**TRANSMITTAL OF EXCAVATION MONITORING SYSTEM DOCUMENTATION AND
RESPONSES TO THE UNITED STATES ENVIRONMENTAL PROTECTION AGENCY AND
OHIO ENVIRONMENTAL PROTECTION AGENCY COMMENTS ON THE AREA 3A/4A
EXCAVATION CHARACTERIZATION AND PRE-CERTIFICATION PROJECT SPECIFIC PLAN**

RESPONSES TO U.S. ENVIRONMENTAL PROTECTION AGENCY
TECHNICAL REVIEW COMMENTS ON THE
DRAFT PROJECT SPECIFIC PLAN FOR AREA 3A/4A EXCAVATION
CHARACTERIZATION AND PRECERTIFICATION
(20200-PSP-0009, REVISION A)

**RESPONSES TO OHIO ENVIRONMENTAL PROTECTION AGENCY COMMENTS
ON THE DRAFT PROJECT SPECIFIC PLAN FOR AREA 3A/4A EXCAVATION
CHARACTERIZATION AND PRECERTIFICATION
(20200-PSP-0009, REVISION A)**

Figure 2.6-2 Procedure for Application of Geometric Corrections for Non-Flat Terrain

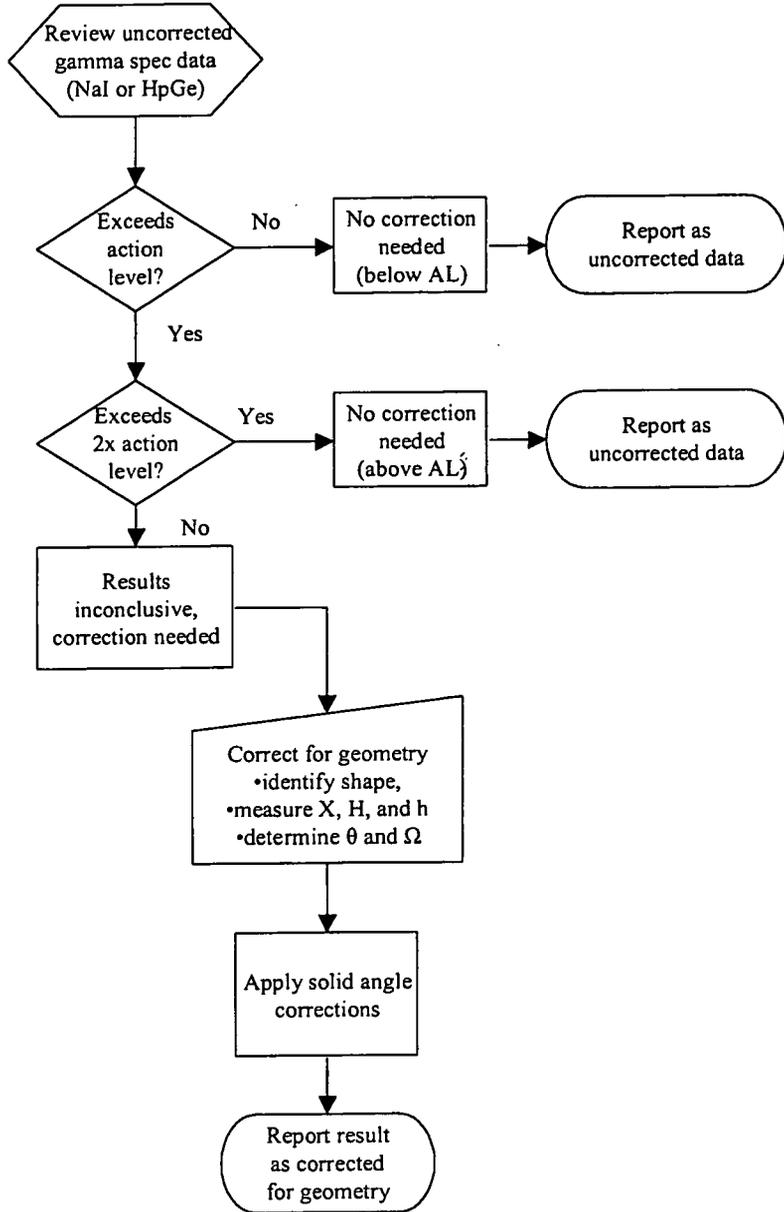
Comment: Corrections for topographic effects in general are largely addressed in the "Users Manual." Specifications for how measurements on steep slopes, pits, and well-like geometry may impact MDC's, trigger levels, system uncertainties, and angular response bias needs to be documented for these systems in order to serve as a template for the remainder of the production area.

Response: As noted in the comment, the general affects on the *in-situ* counting statistics due to a deviation from the 2 pi geometry are addressed in the User Guidelines, Measurement Strategies, and Operational Factors for Deployment of *In Situ* Gamma Spectrometry at the Fernald Site (User's Manual, Revision B). The User's Manual describes the deviation caused by measuring other than flat ground would in all cases be an overestimation up to a factor of two at maximum. The technical basis for the User's Manual has since its development been documented by the Department of Energy, Environmental Measurements Laboratory (DOE-EML) in EML-603, "Fluence Evaluations For Applications of *In Situ* Gamma Spectroscopy in Non-Flat Terrain". EML-603 provides mathematical corrections for deviations from the half-space geometry. The equations in EML-603 have been used to provide geometry corrections in the EMS Report. To perform these corrections the solid angle subtended by the soil will be determined and documented for these types of measurements. This correction will be implemented only in the case if waste acceptance criteria (WAC), hotspot criteria, and or final remediation levels (FRLs) are exceeded in the uncorrected results based on the application of the trigger levels. Section 5.3.3 of the EMS Report discusses the geometric corrections.

16
17 For nearly all cases that will be encountered in FEMP excavations, the effects due to non-flat terrain are
18 such that results will be biased high. That is, measurements are conservative. In cases where such a
19 conservative bias leads to unnecessary excavation, corrections for non-flat geometry may be applied to
20 obtain more accurate measurements. Figure 2.6-2 shows the procedure for making geometric corrections.

21
22 As shown in the figure, readings below the action levels will not require correction because any such
23 correction would only reduce the reading further, assuming a positive bias for all below-grade readings.
24 Conversely, all readings in excess of twice action levels would indicate an above-action level condition,
25 because the maximum correction for geometry is a factor of two. Readings between the action level and
26 twice the action level are thus inconclusive and warrant correction for geometry.
